SERVICE LETTER

No. 650

Inspection of Landing Gear Retraction and Flap Control Transmission Assemblies

SUBJECT: Identification of Serviceable/Non-Serviceable Landing Gear Retraction and Flap Control Transmission Ball Screws

Flap Control Transmission Assembly

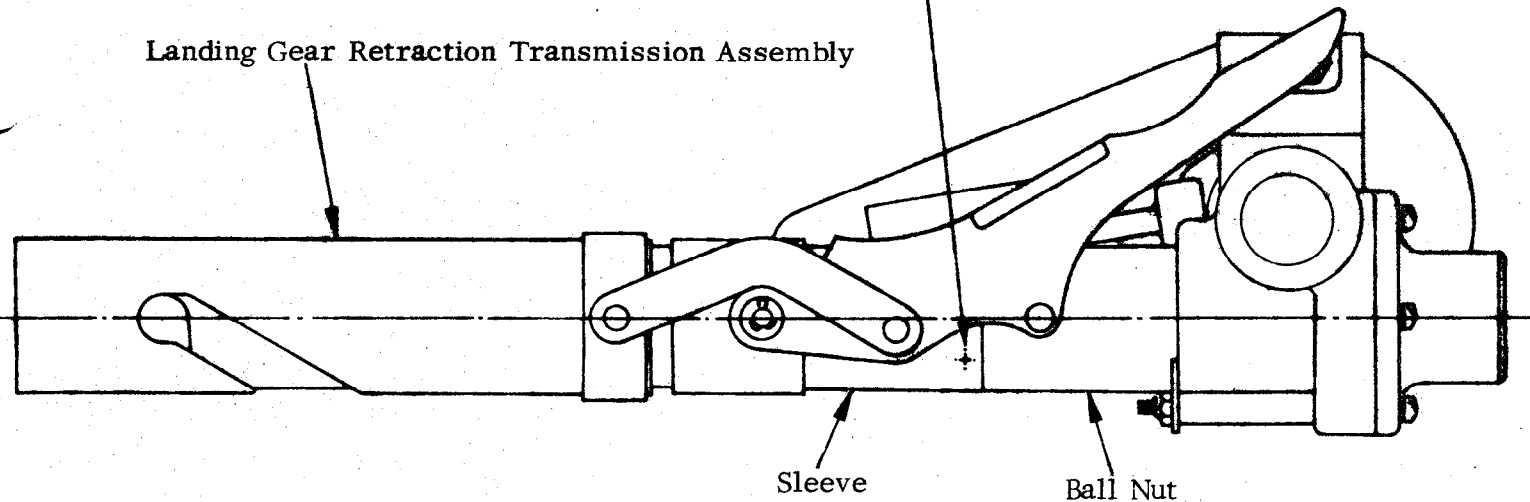
Sleeve must be staked at three points
(on circumference of sleeve) to prevent
separation of threaded joint.

1. Refer to the appropriate Service Manual and gain access to the flap control transmission (if installed) and the landing gear retraction transmission.
2. Inspect transmissions to determine if sleeve has been properly staked as shown on above sketch.
3. If the transmission sleeves have been properly staked, no further action is required.
4. If either of the transmission sleeves have not been staked, it will be necessary to remove the transmission from the airplane and stake as shown (sleeve must be tight against ball nut before staking). Use a center punch and carefully stake to a depth of .030 to .040 inches. Refer to the appropriate Service Manual for proper Removal and Installation Procedures.

- REFERENCE SERVICE LETTER NO. 650: Purpose II
Identification of Transmission Ball Screw;
Transmission serial numbers 919 thru 1068 inclusive.

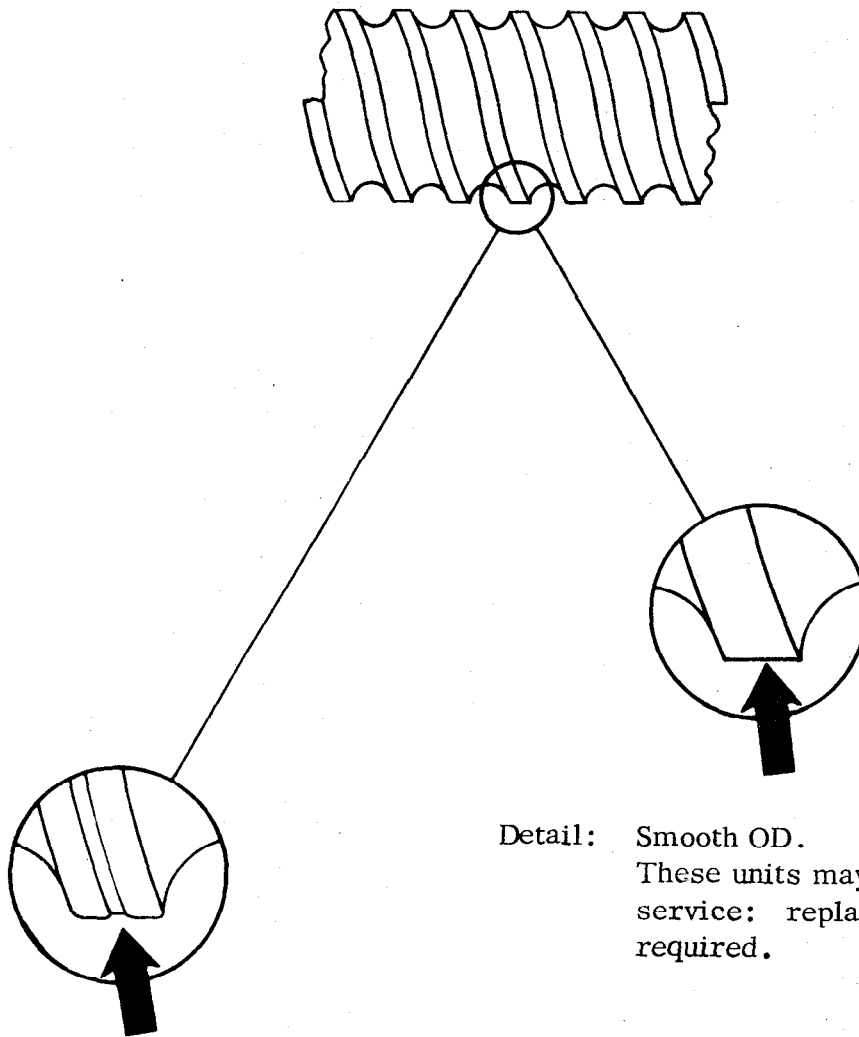
1. Expose the threaded ball screw portion of the transmission assembly to view.
2. With a magnifying glass, inspect the threads as specified on the sketch on the reverse side of this communication.
3. Refer to the "detailed" call-outs on the sketch to determine whether the transmission assembly must be replaced.
4. Refer to the balance of Piper Service Letter No. 650 for replacement material identification data.

Detail: Grooved OD.
These units must be replaced.

Detail: Smooth OD.
These units may remain in
service: replacement not
required.
